April 3, 2024

**PUBLIC WORKS BUILDING ADDITION AND RENOVATIONS  
BOROUGH OF CAPE MAY POINT**

**ADDENDUM NO. 1**

**1** **DETAIL AT FOUNDATION**  
 SK-1 1 1/2" = 1'-0"

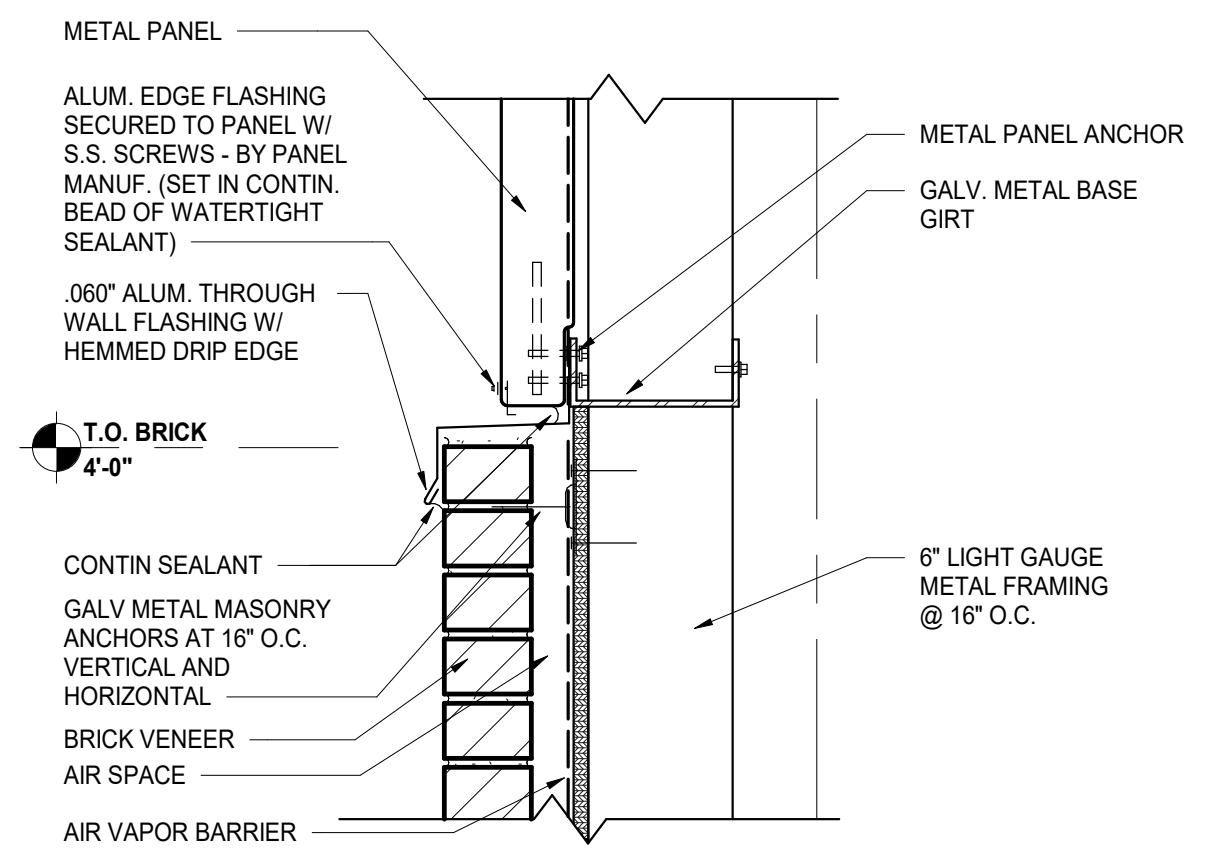
Attached are details of the Brick Façade Construction and Sketch SKS-1.

1. Drawing A-101A references Alternate Elevations, No Alternates found in the bid form. **Response:** *Bid Form has been revised to reflect alternate bid items.*
2. Drawing A-101A reflects a masonry lower wall at proposed west elevation but no clear details found. **Response:** *Details of the brick façade are included as part of this Addendum.*

9. A-101A provides alternate elevations which appear to include the brick shelf from question 3, the bid form does not include a space for alternate pricing. Please advise if this drawing should be omitted. If not, please provide details for how the brick façade ties into the framing of the ETR metal building. **Response:** *Details of the brick façade are included as part of this Addendum.*

**2** **DETAIL AT PANEL AND BRICK**  
 SK-1 1 1/2" = 1'-0"

TYPICAL DETAIL - COMPOSITE FOOTING  
 SCALE: NTS

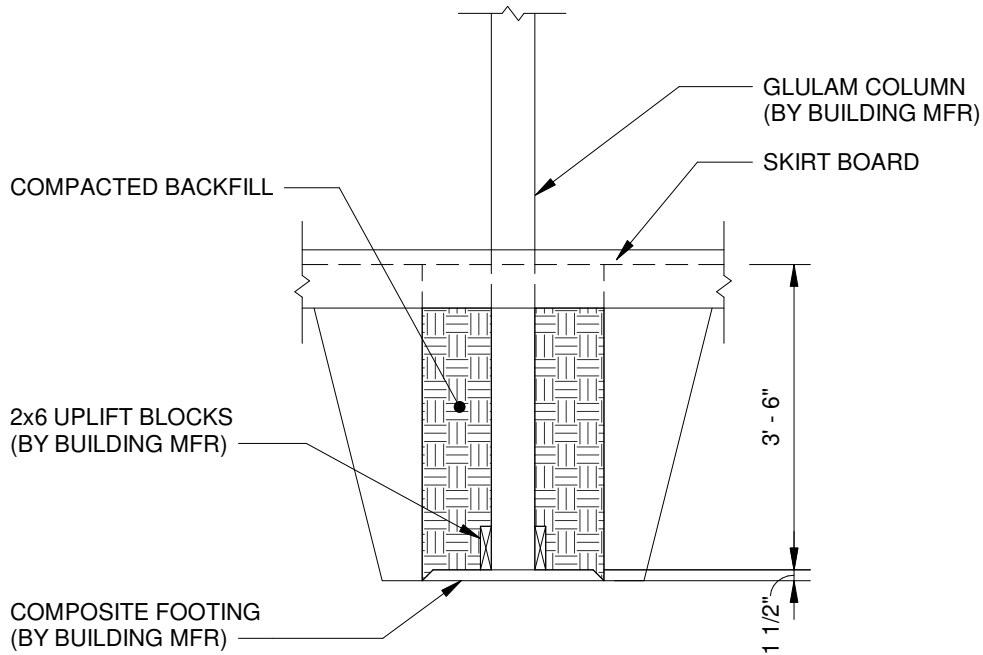
Sheet S-101, Plan A/S-101: *Revised the callout in the lower left of the Plan to read "COMPOSITE FTG (TYP) SEE SKETCH SKS-1.*

6. Drawing S-101 notes to refer to prefab building shop drawings for composite footings at columns 1&4/H, and 1&4/G. Please provide footing details. **Response:** *The footing detail is included as part of this Addendum.*

1. THIS TYPICAL COMPOSITE FOOTING DETAIL WAS USED AS THE BASIS OF DESIGN & SHALL BE PROVIDED BY THE MANUFACTURER/DESIGNER OF THE MAINTENANCE GARAGE STRUCTURE. GC TO VERIFY THIS DETAIL WITH THE EOR AFTER OBTAINING SHOP DRAWINGS OF THE FOOTING DETAILS OF THE STRUCTURE.
